**Attachment 1:**

**Further information requested under Section 92 of the Resource Management Act 1991**

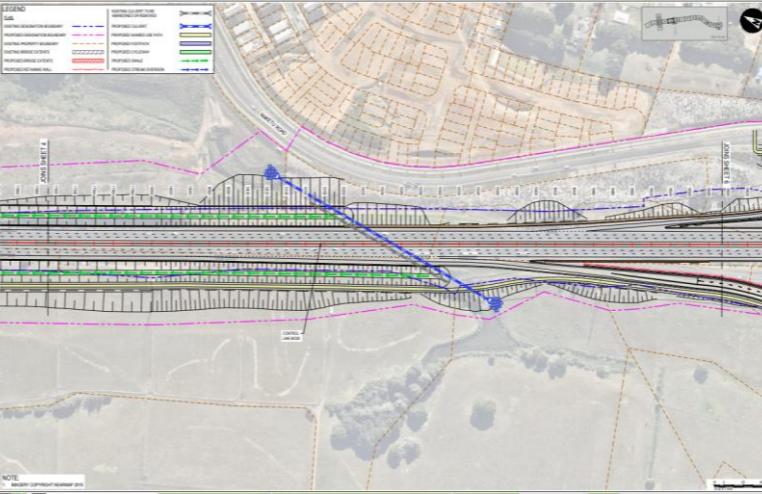
HW20	Section 8.5	SMAF-1 design criteria is proposed within the FUZ/greenfield environments, where discharging to freshwater streams.	To better understand the flood management.	<ul style="list-style-type: none"> <li>Regarding the concerns of the Hingaia Stream actively eroding, Chapter E1- of the AUPOP SMAF-1 is a regional consenting matter under Section 9(2) of the RMA (refer to Rule E10.4, AUPOP). The detailed design and location of</li> </ul>	The AEE has referenced the SMAF hydrology mitigation requirements.

#	Category of information	Specific Request	Reasons for request	NZTA Response, dated 07/05/2024	Comments
	AEE Revision: A, 16/02/2024	<ul style="list-style-type: none"> <li>The proposed designation will also cover areas that are not within FUZ/greenfield environments and discharge to freshwater streams, will SMAF-1 be used in these areas, please provide reasoning.</li> </ul> <p>The Hingaia Stream is actively eroding.</p> <ul style="list-style-type: none"> <li>Please discuss if the use of SMAF-1 will be sufficient to mitigate effects on the stream environment caused by the change in land use such as erosion, instream habitat changes, etc.</li> <li>Please demonstrate whether SMAF-1 is the Best Practicable Option, accounting for the existing state of the stream and its vulnerability to erosion.</li> </ul>		<p>stormwater outfalls to the Hingaia Stream, will be determined at the detailed design stage. Any future stormwater outfalls discharging to the Hingaia Stream will require resource consent at a later date. This process will afford Healthy Waters sufficient opportunity to assess any potential adverse effects (be it erosion and sediment control measures) on the Hingaia Stream, however this is not a matter to be addressed through the Notice of Requirement.</p> <ul style="list-style-type: none"> <li>As above, SMAF-1 is a regional consenting matter. The Project must consider the relevant AUPOP rules at the time of construction (i.e. 15-20 years). Notably, the Project will not alter the land-use and is rather intended to enable infrastructure to be installed at a time the land use changes indicate its requirement.</li> <li>As above, at the time of detailed design, it will be pertinent for NZTA to assess the state and vulnerability of the Hingaia Stream and prepare a design for any future stormwater outfalls in accordance with the requirements of the AUPOP.</li> <li>It is also apparent from discussions with Healthy Waters on another project that erosion in the Hingaia Stream is an existing issue and that a wider solution to this may be required and implemented prior to the construction of the Project.</li> </ul>	<p>During the Unitary Plan process the future urban areas were excluded from the SMAF management layer on the basis that during structure plan and plan change processes the most appropriate method of hydrology mitigation could be applied/determined, noting the Hingaia Stream is actively eroding.</p> <p>We anticipate that at Resource Consent stage the applicant will be required to demonstrate that the use of SMAF type mitigation will be sufficient to mitigate effects on the stream environment caused by the change in land use such as erosion, instream habitat changes, etc. Any proposed hydrology mitigation should demonstrate that it is the BPO accounting for the existing state of the stream and its vulnerability to erosion.</p>

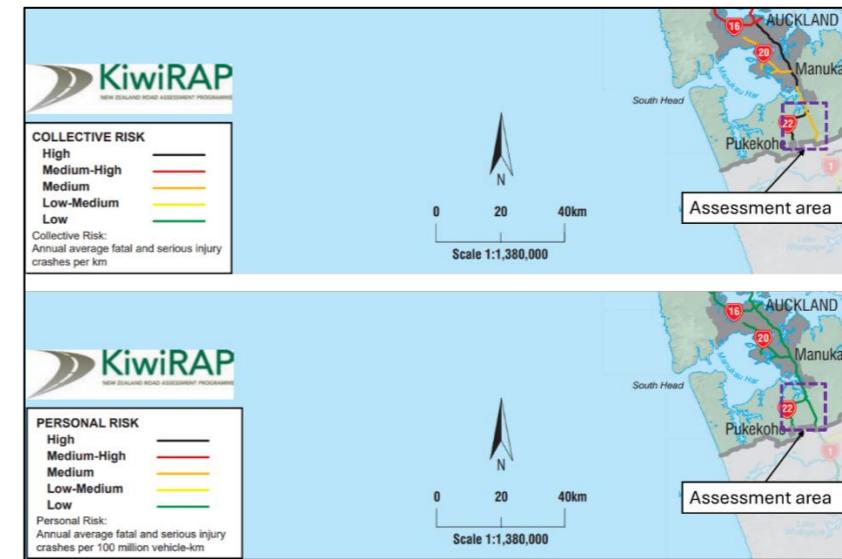
T5	NOR 5 Future Corridor – Intersection with Maketu Road	<ul style="list-style-type: none"> <li>• Please undertake traffic modelling of this intersection</li> </ul>	<p>The intersection traffic modelling presented in Appendix C does not cover the intersection with Maketu Road. Please can a modelling assessment of this intersection be provided, to determine whether its operation and queue generation will adversely impact upon the adjacent roundabout intersections to the west.</p>	<p>The intersection modelling documented in <b>Appendix C</b> (Assessment of Effects on Transport and Traffic) includes the Maketu Road intersection. This intersection is the 5-leg roundabout that forms the eastern side of the interchange. Refer figure below from Appendix C.</p>	<p>Unfortunately, the original request item contained an error and should in fact be referring to the intersection with Quarry Road, not Maketu Road, i.e. the intersection at the easternmost end of NOR 5:</p>

#	Category of information	Specific Request	Reasons for request	NZTA Response, dated 07/05/2024	Comments
				 <p>The critical approaches to this interchange, in terms of queue potential onto the motorway, include the SH1 overbridge and the SB off ramp. No significant queues were predicted on either of these approaches (1-3 vehicles during peak periods).</p>	
T6	Crash Analysis, Chapter 5 of Assessment of Transport & Traffic Effects (ATE)	<ul style="list-style-type: none"> <li>Please provide a more detailed crash analysis, including a breakdown of crash types and crash trends along the corridor</li> </ul>	<p>The crash analysis in Chapter 5 is high level and provides no breakdown of crash types by location. A more detailed crash analysis, including a breakdown of crash types and crash trends by location along the corridor would assist with providing more insight into existing trends and opportunities to reduce crashes, particularly at and in the vicinity of key interchanges, where major changes are proposed.</p> <p>In the case of crashes near the proposed new Drury South Interchange, it would be useful if the location and outline for the interchange could be confirmed on the crash plot.</p>	<p>We have undertaken a crash assessment for the Project area for the time periods between 1 January 2016 to 15th February 2020, and for 1 January 2023 to 15th August 2023 (16th February 2020 to 31 December 2022 was avoided due to COVID-19 impacts)<sup>1</sup>. Our crash analysis included SH1 south of the Drury interchange (by Pitt Road) to the SH1 / Mill Road Bombay Interchange.</p> <p>The key findings of the crash assessment are:</p> <ul style="list-style-type: none"> <li>A total of 193 recorded crashes</li> <li>Crash numbers by severity: <ul style="list-style-type: none"> <li>0 fatal crashes.</li> <li>6 (3%) serious injury crashes.</li> <li>45 (23%) minor injury crashes.</li> <li>142 (74%) non-injury crashes.</li> </ul> </li> <li>Crash numbers by crash type: <ul style="list-style-type: none"> <li>38 (20%) overtaking crashes.</li> <li>64 (33%) straight road lost control / head on crashes.</li> </ul> </li> </ul>	I am satisfied with the level of information provided in relation to this item.
